Applicant: Adam Wilford; UnitedHealth Group
Consultant: Gretchen Schroeder; Westwood Professional Services
Project: Drop-off Access Drive and Site Improvements
Location: 11030 Optum Circle, Eden Prairie
Applicable Rule(s): 4, 5, 11 and 12
Reviewer(s): Louise Heffernan; Barr Engineering Co.

General Background & Comment

The current permit application (project), Permit #2024-079, proposes to disturb 0.21 acres of the site. The relevant project information includes:

Figure 1. Project area.

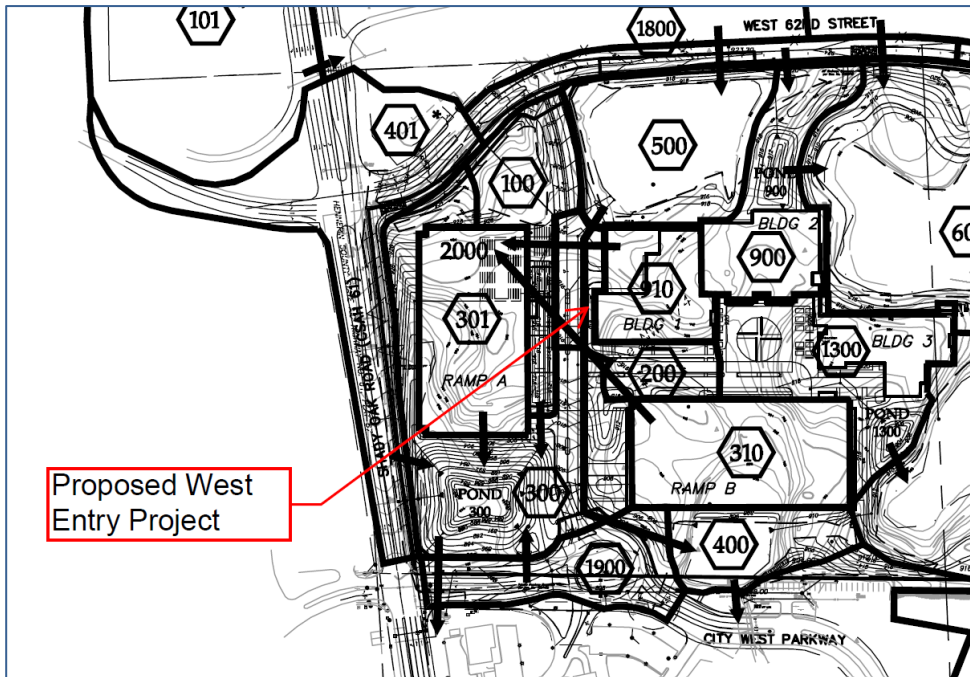
The project area is shown on Figure 1 below.

Stormwater management for compliance with subsection 4.3.1 criteria for the project will be provided by the excess capacity in the existing stormwater management facilities permitted and constructed under Permit #2011-065 to provide rate control, volume retention and water quality management for the newly regulated area. Stormwater runoff from the newly regulated area will be directed from Drainage Area 200 to Infiltration System 2000 under Ramp A and then to Pond 300 as shown on Figure 1 above.

GRADING AND EROSION CONTROL PLAN

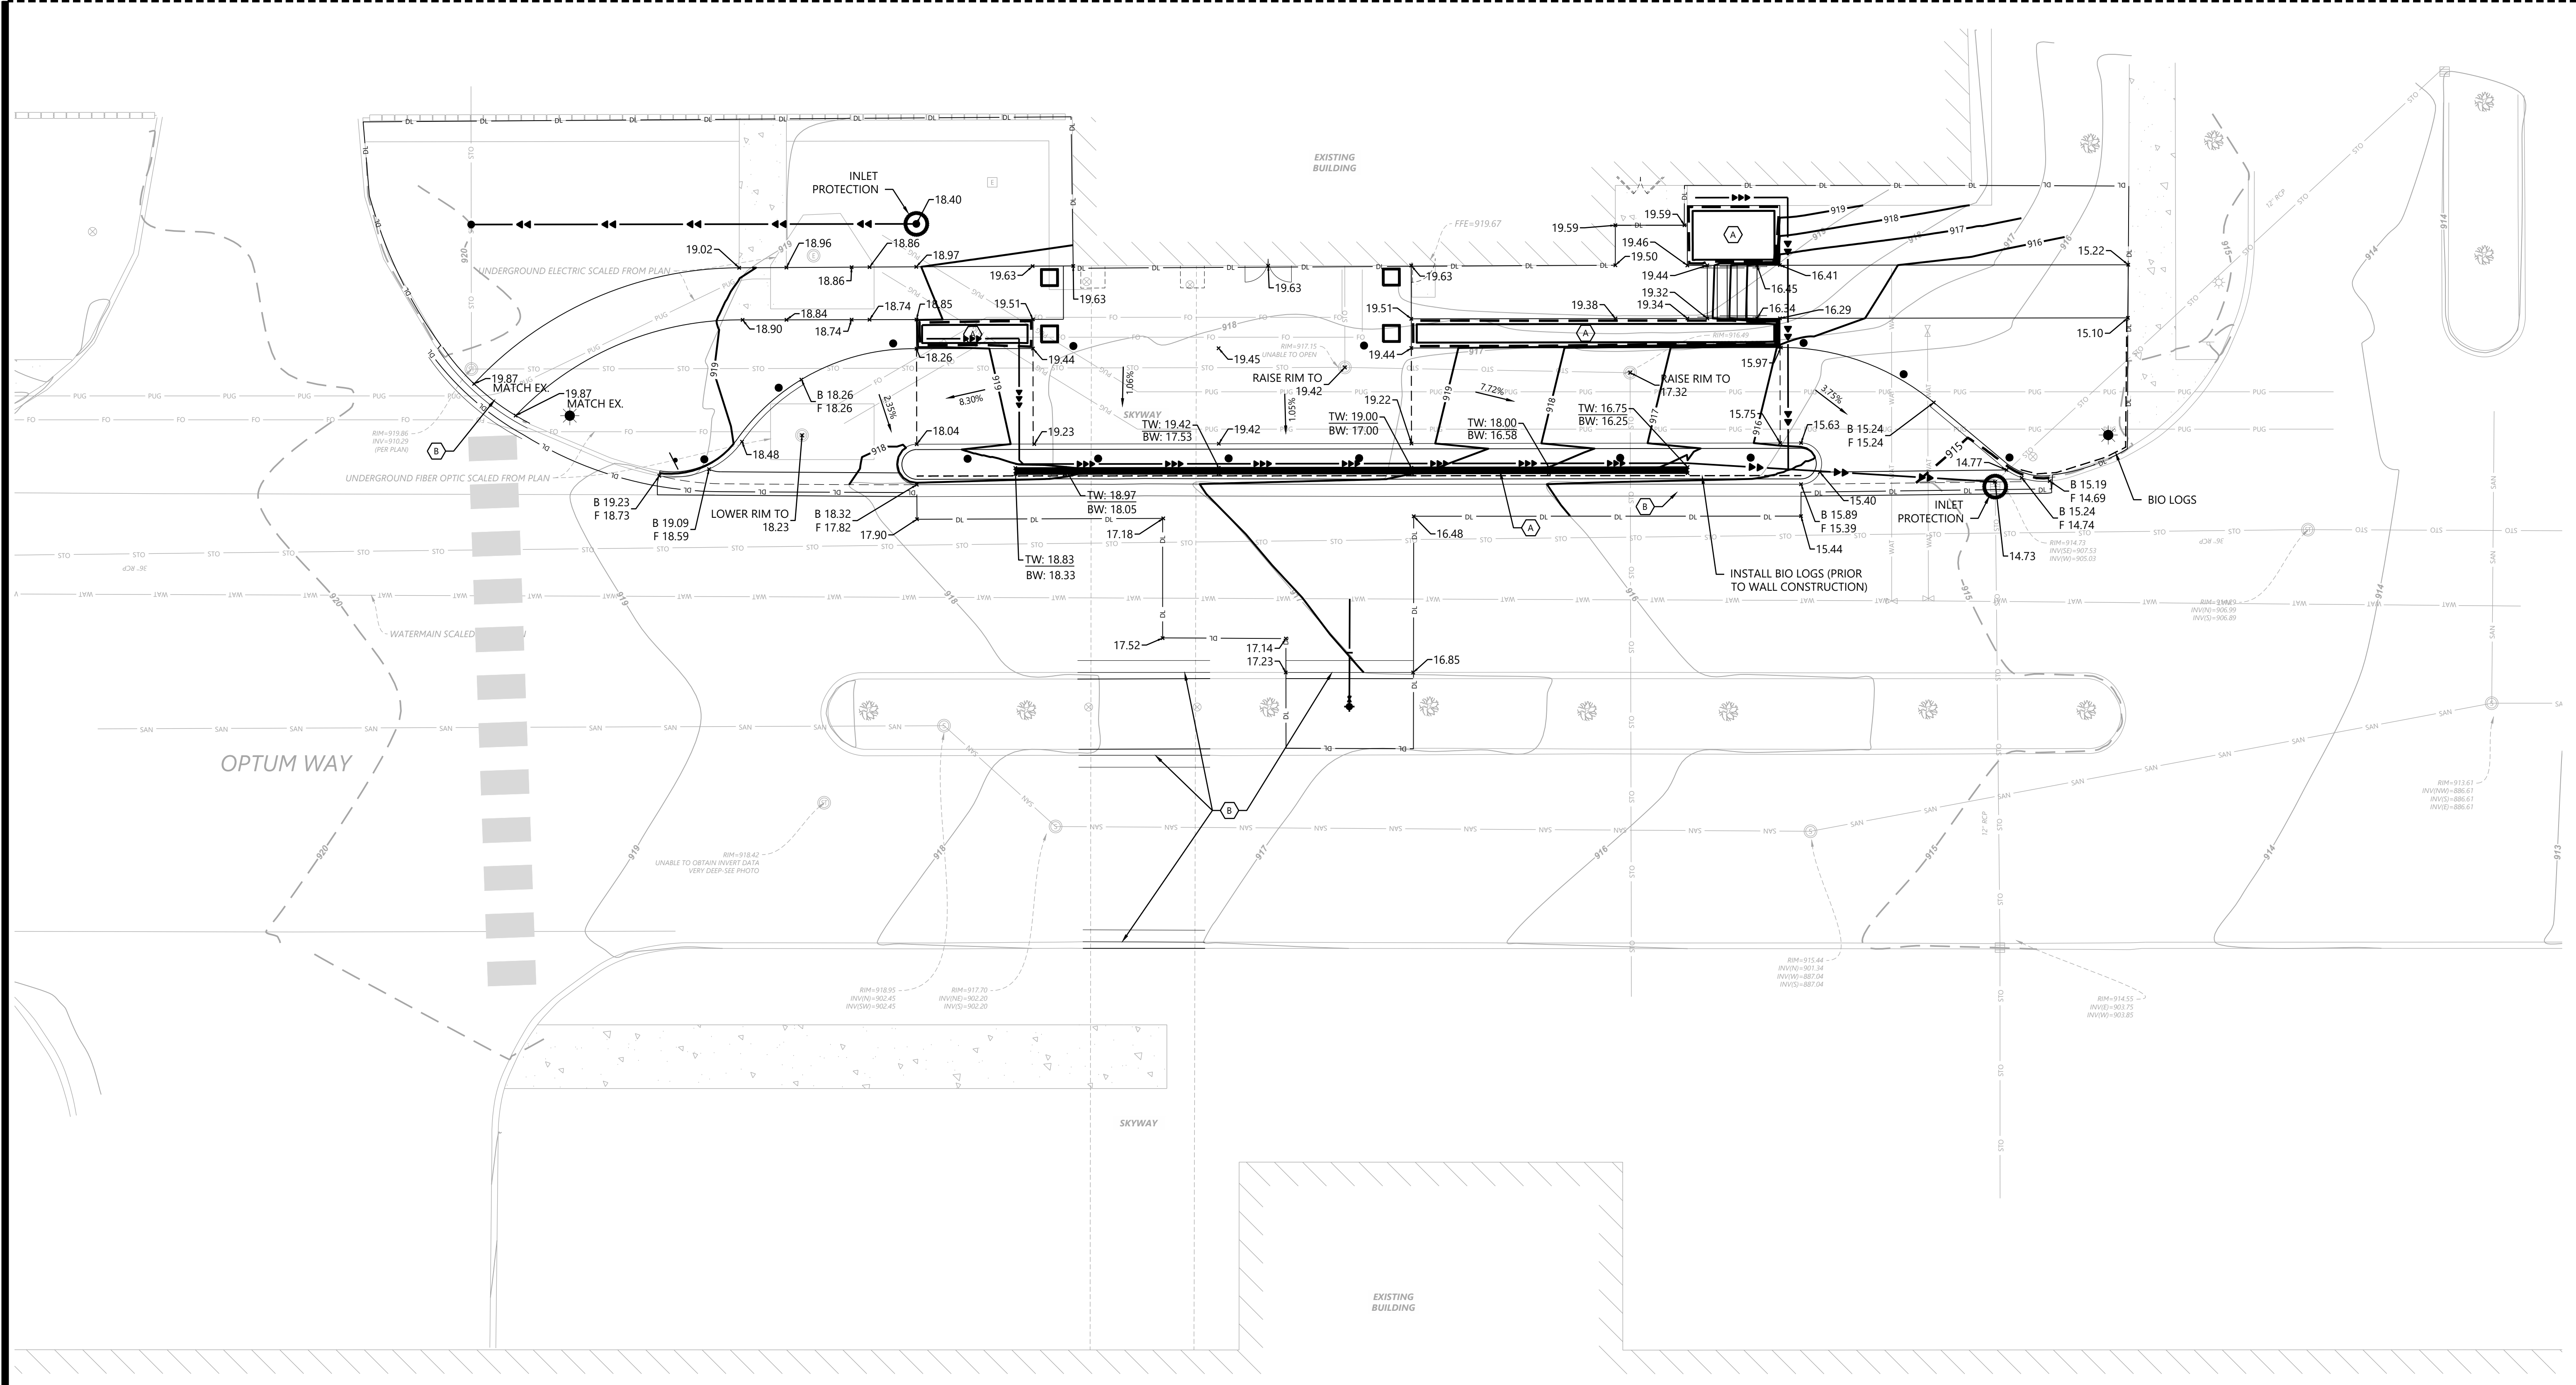
The erosion control plan prepared by Westwood Professional Services includes installation of perimeter erosion control (bioroll and silt fence), inlet protection, and a construction entrance.
